STATE OF NORTH CAROLINA
DEPARTMENT OF TRANSPORTATION

Subject: **Application for Modification of the Section 404 Individual Permit, Section 401 Water Quality Certification, and Riparian Buffer Certification** for the Continuation of Greensboro-High Point Road (SR 4121) on New Location in Guilford County, Federal Aid Project No. STP-4121(1), Division 7, TIP No. U-2412 A, Debit \$570 from WBS 34802.1.1.

**Minutes from the Interagency 4C Permit Drawing Review Meeting
U-2412A in Guilford County
September 21, 2017
NCDOT Century Center
10:00 AM – 12:00 PM**

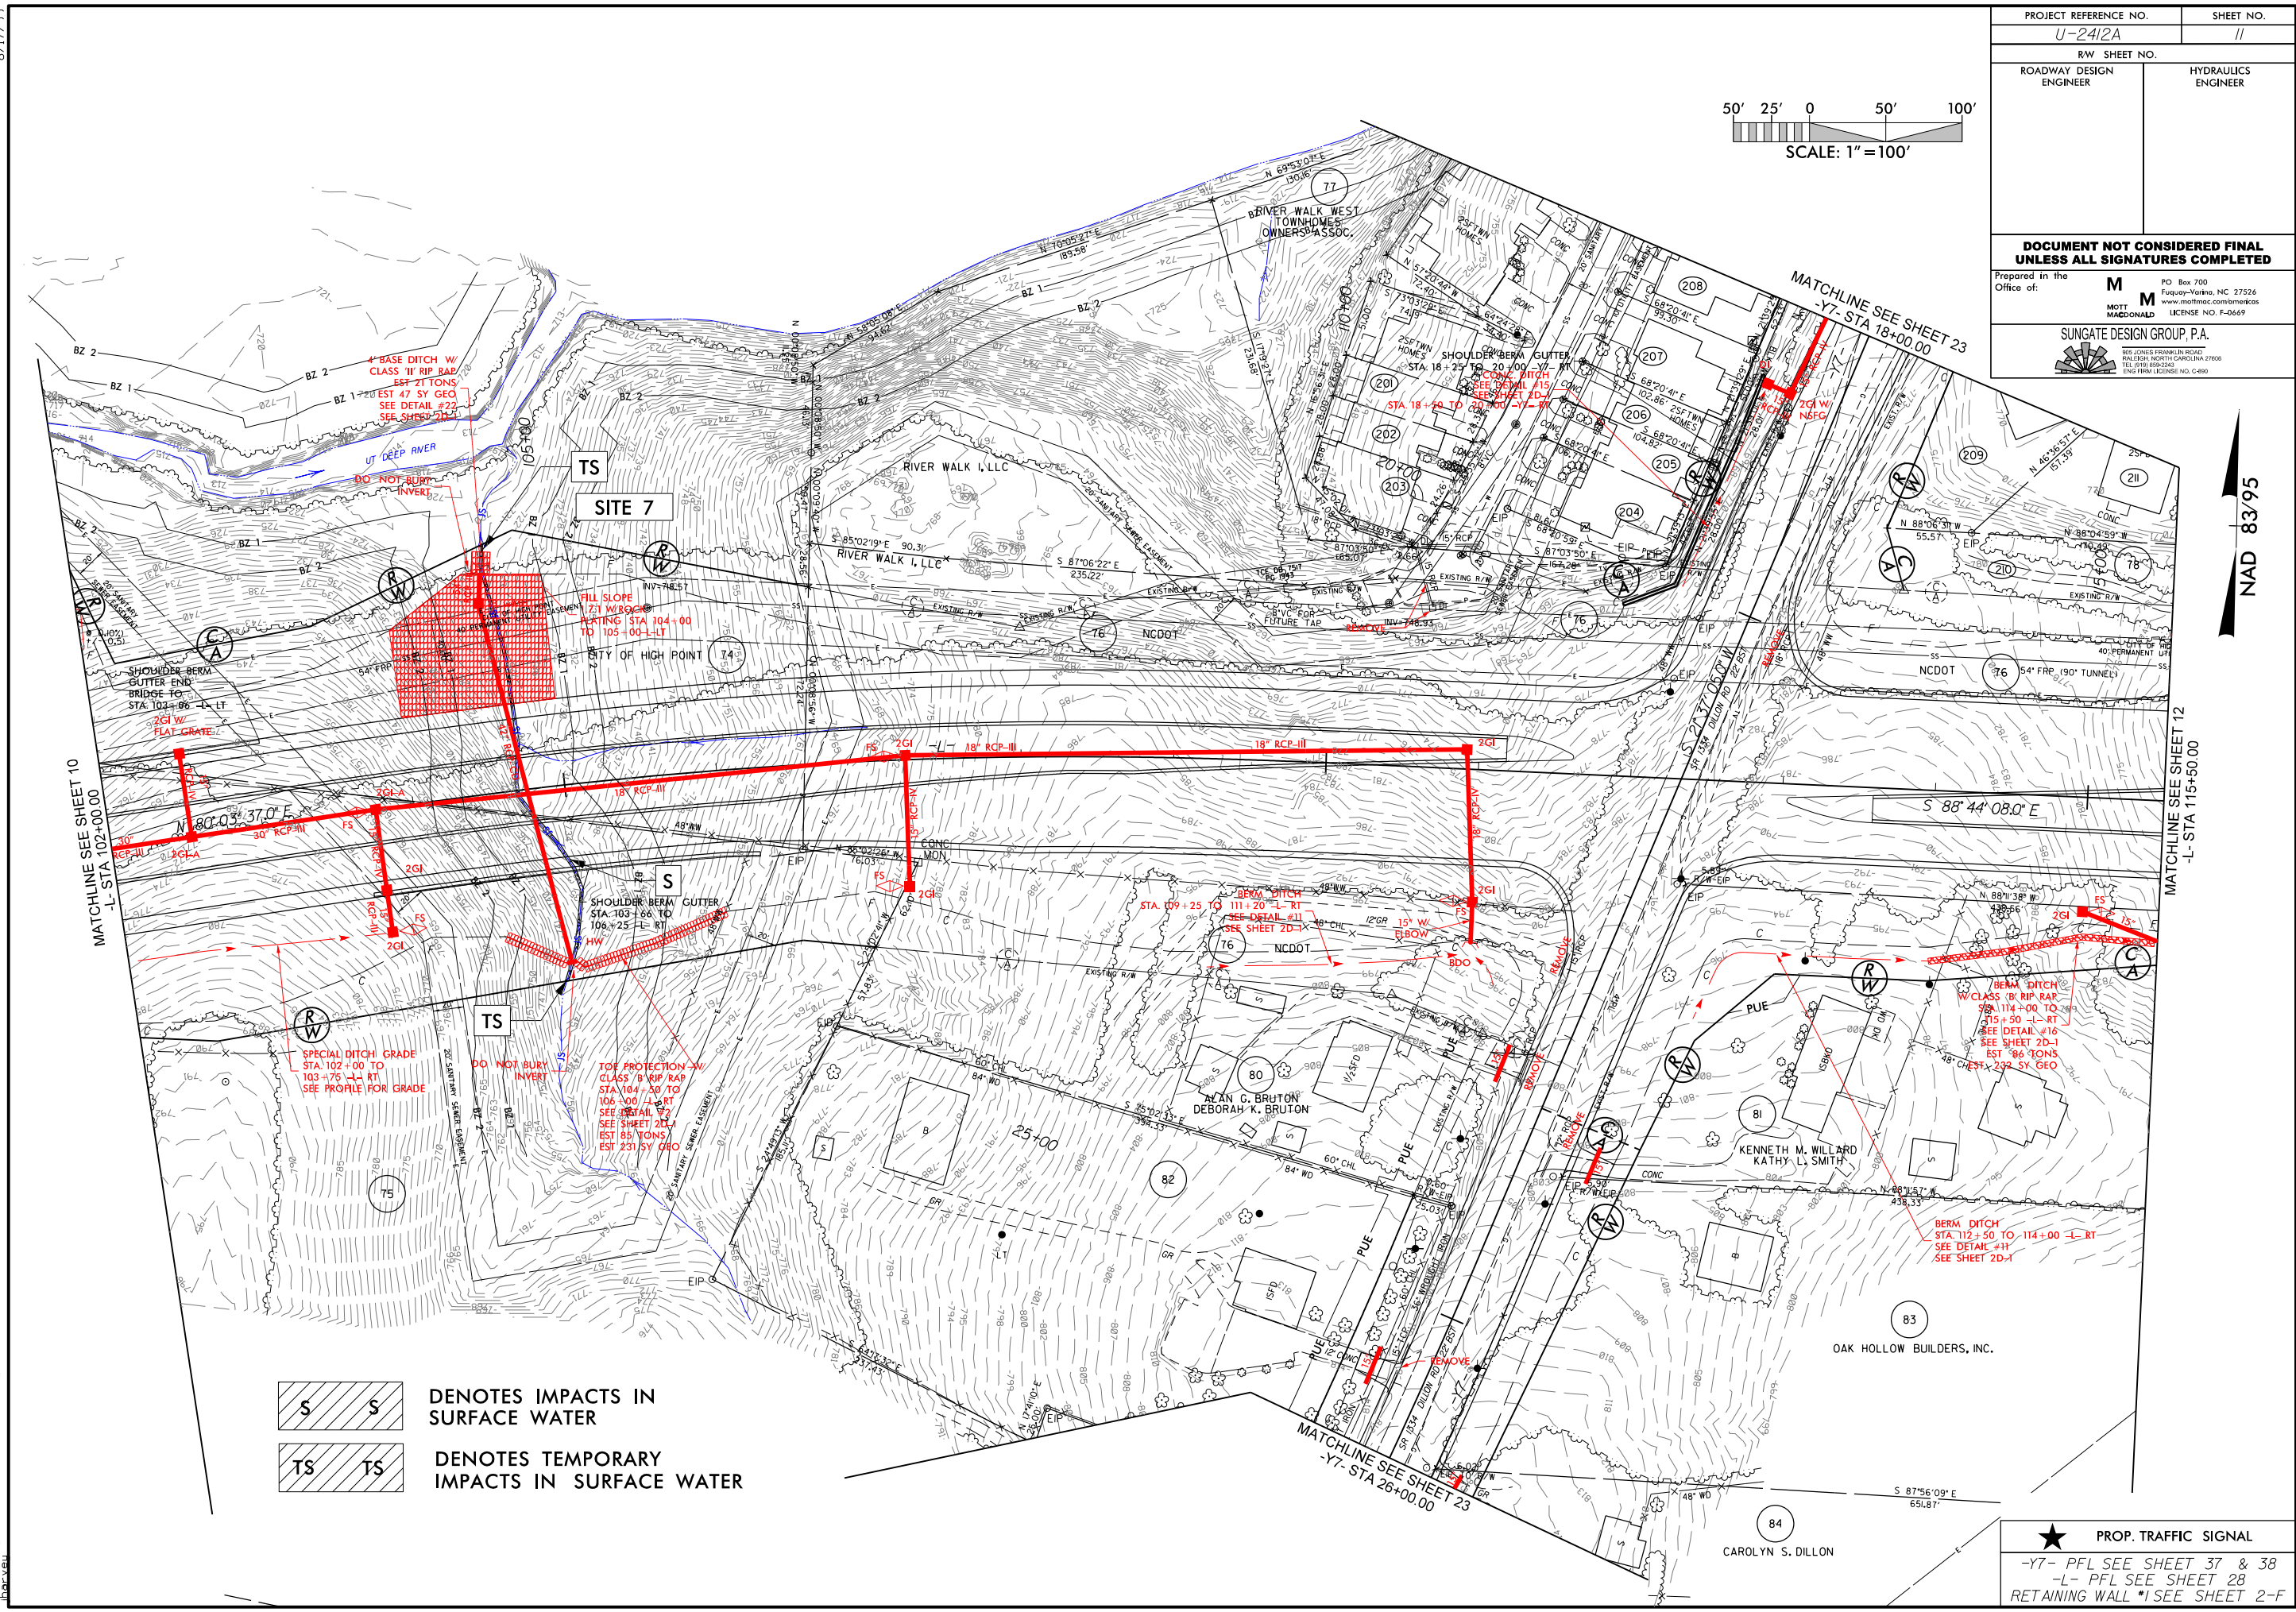
Site 7 (Plan Sheet 11):

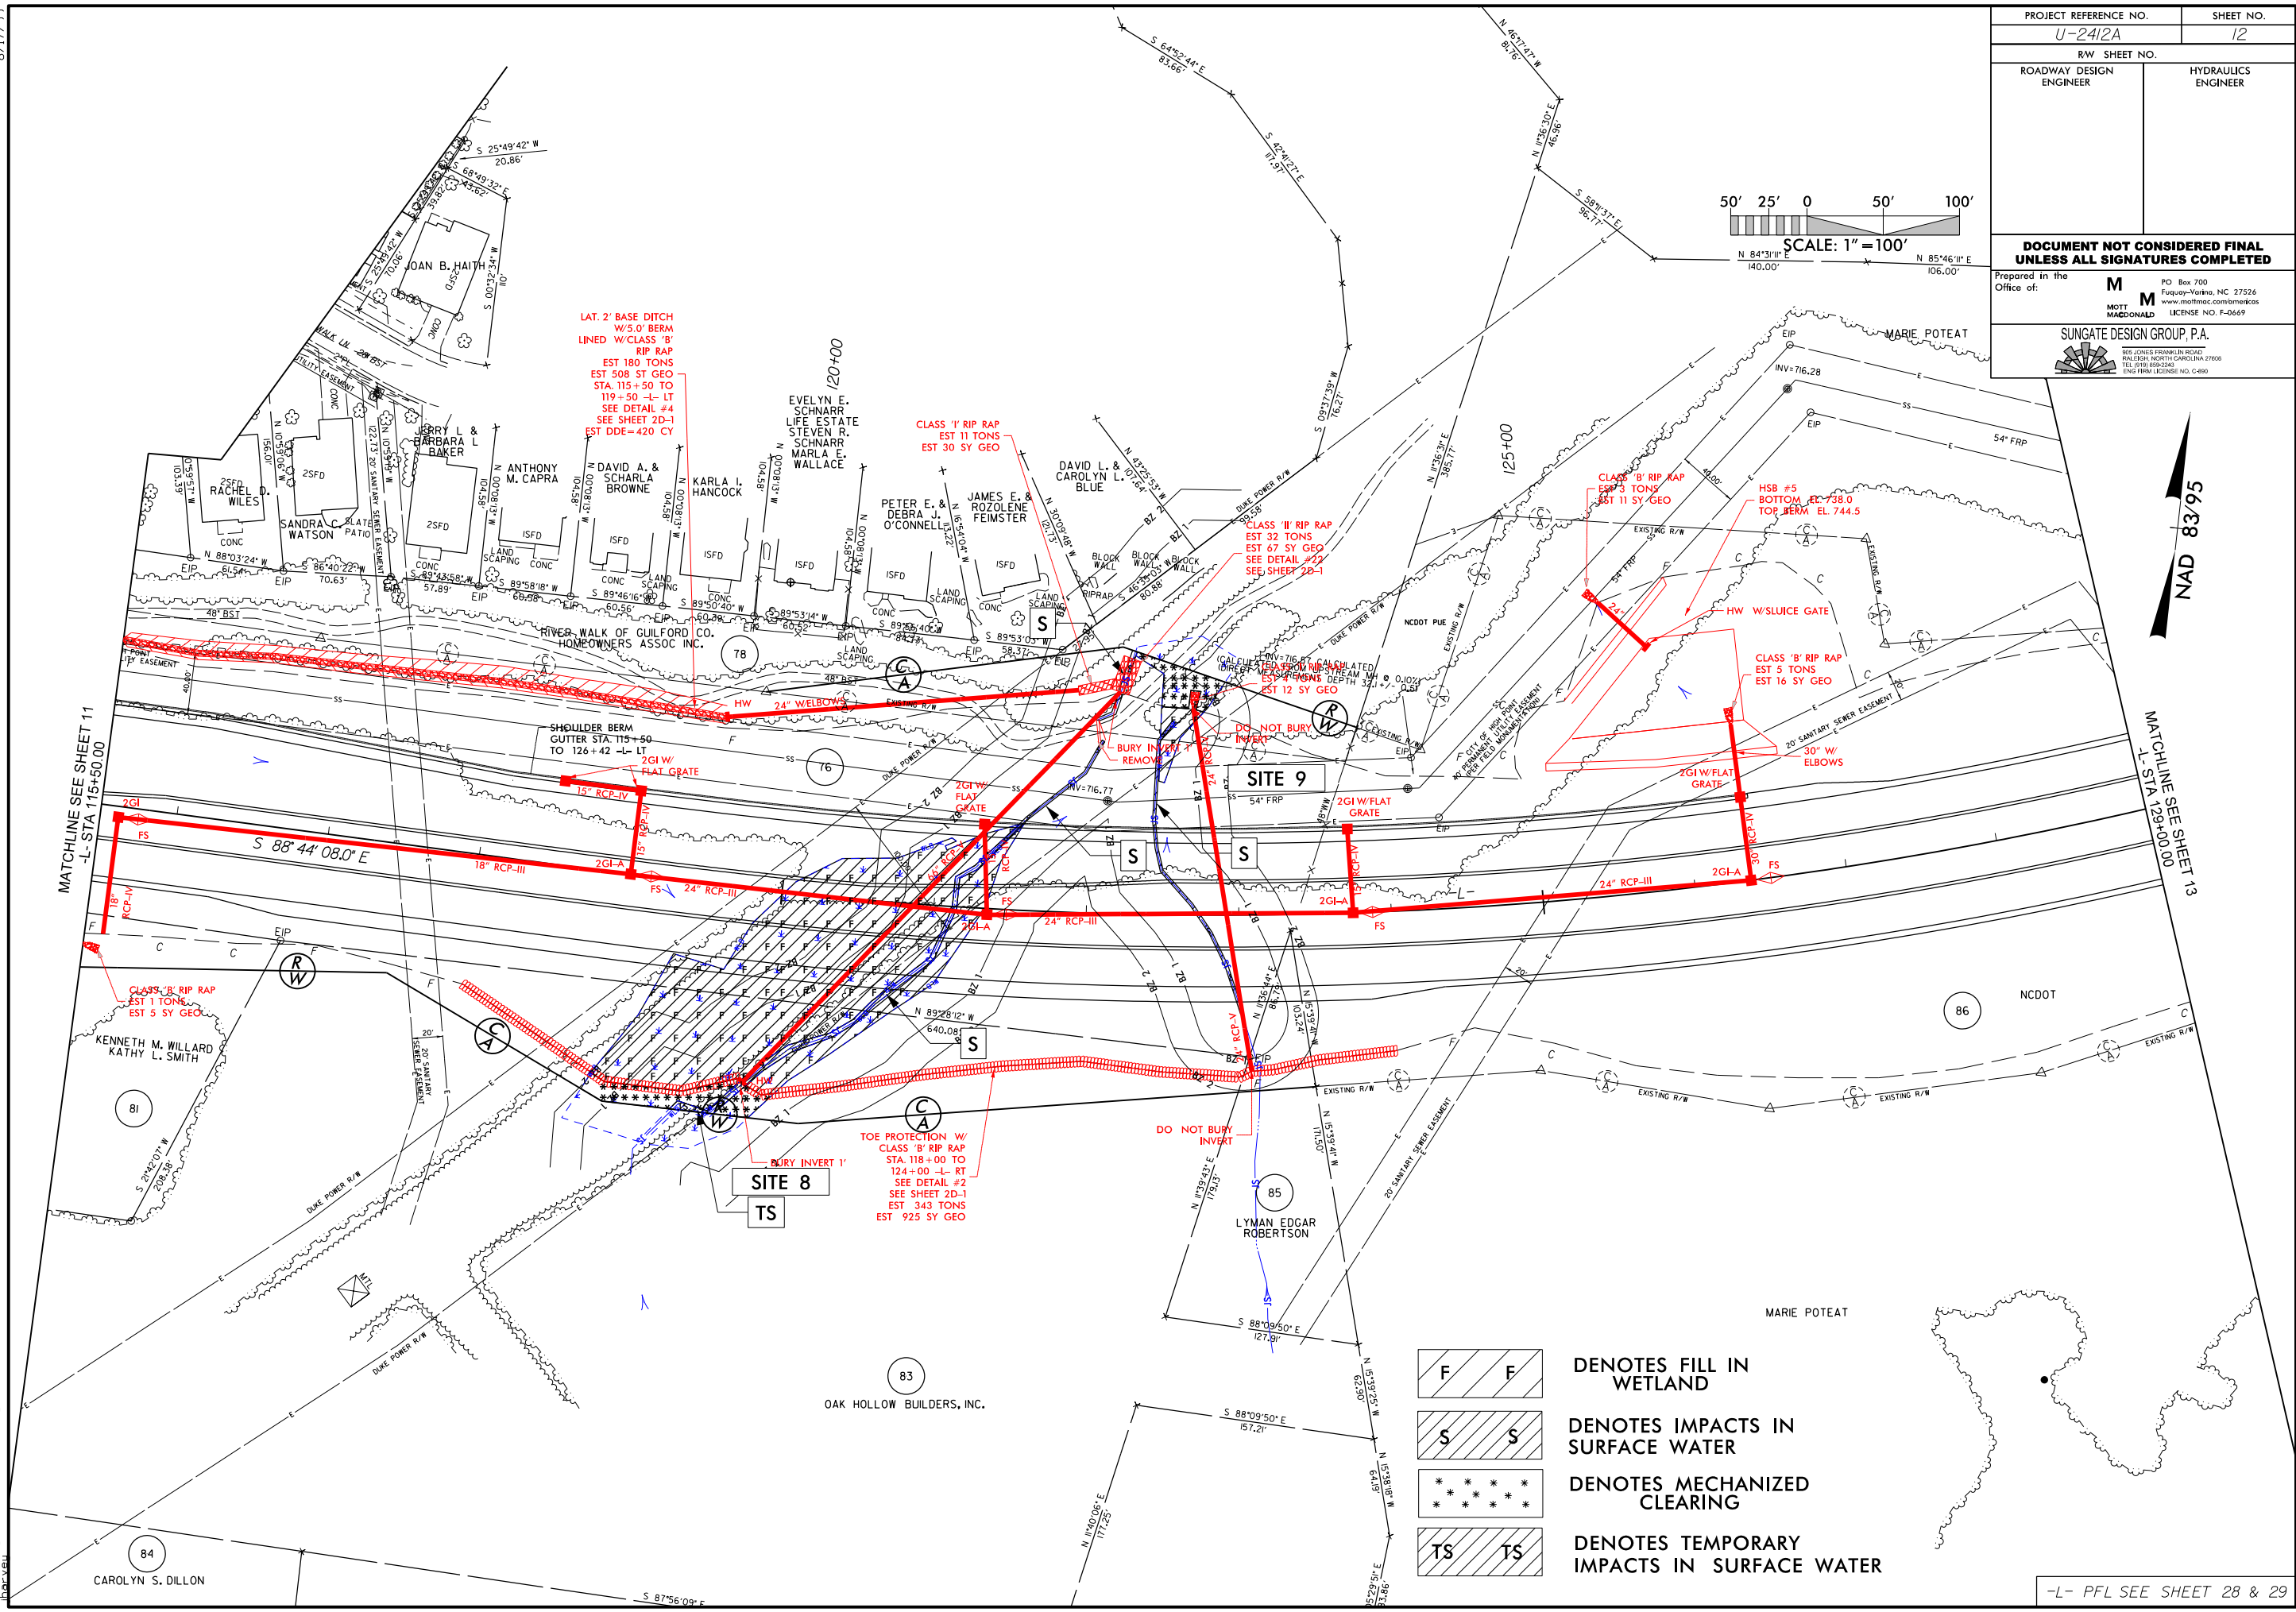
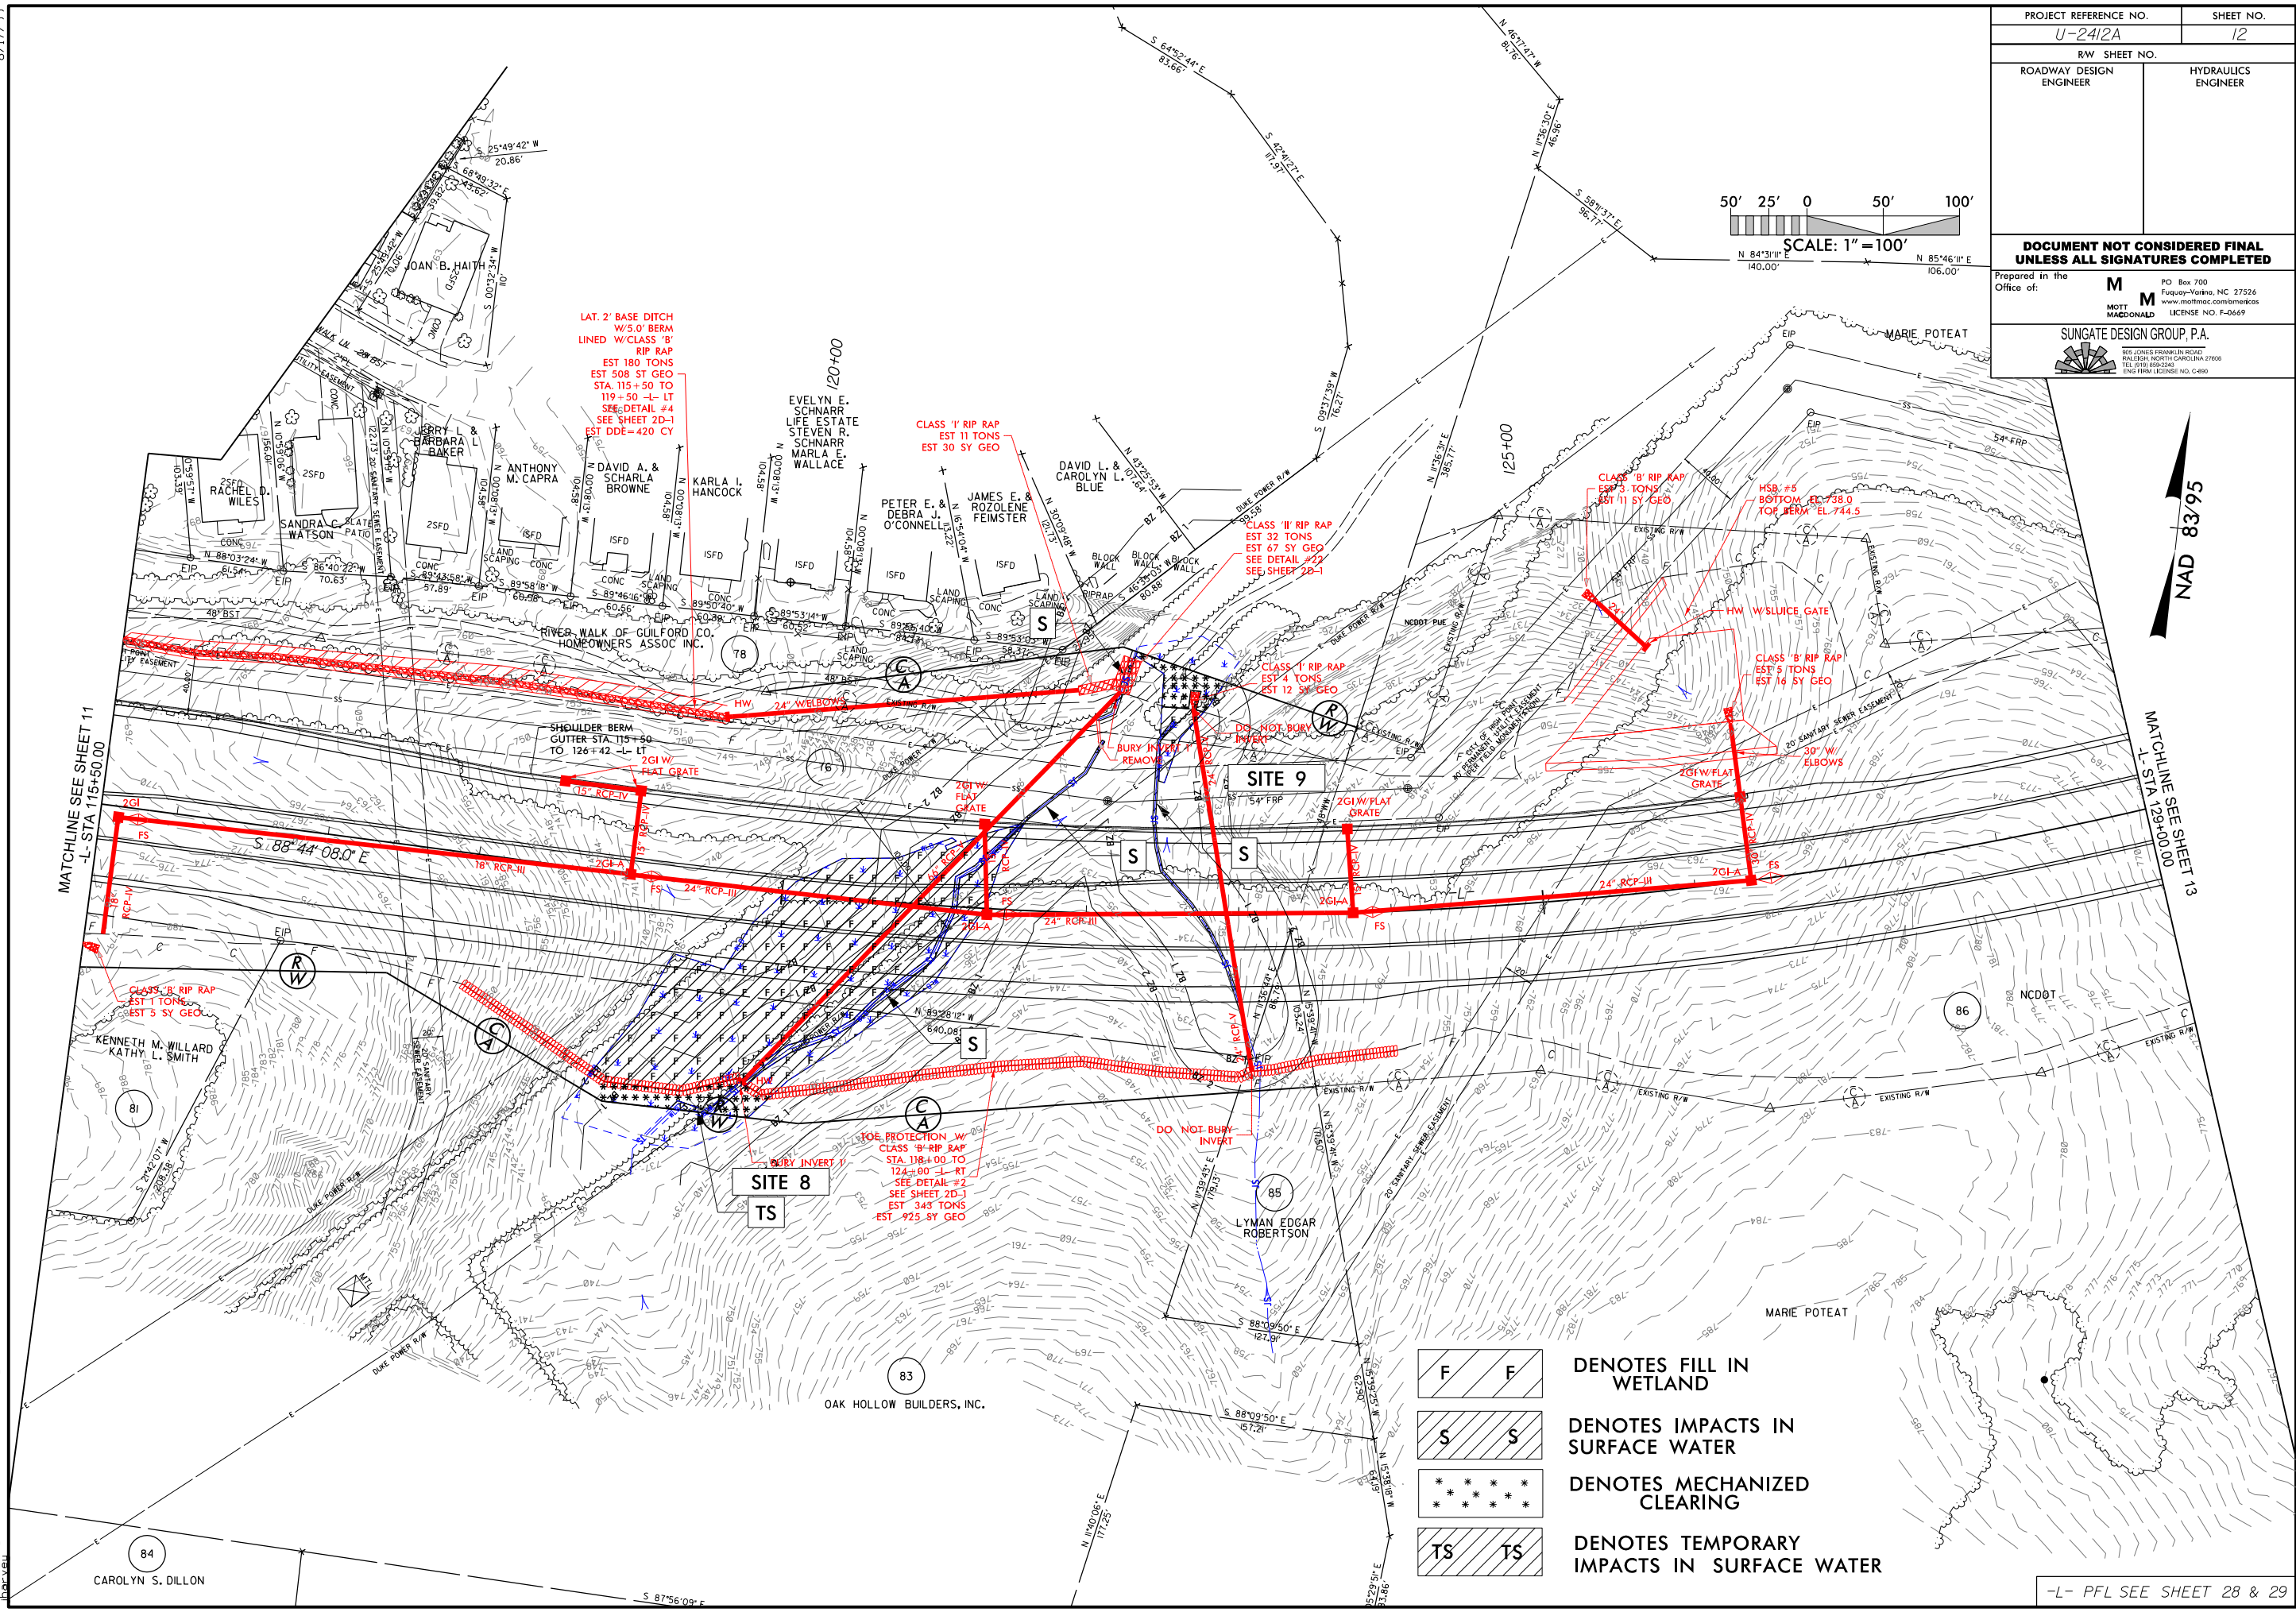
Site 8 (Plan Sheet 12):

- There is a second JS at this site. Break it out as Site 8A on the drawings and summary.
- Show mechanized clearing of wetlands to ROW line on upstream side.
- Take rip rap all the way to the stream from the outlet of the 24" pipe left of station 121+90 -L-. If possible, back pipe outlet away from stream but stay off steep slope.
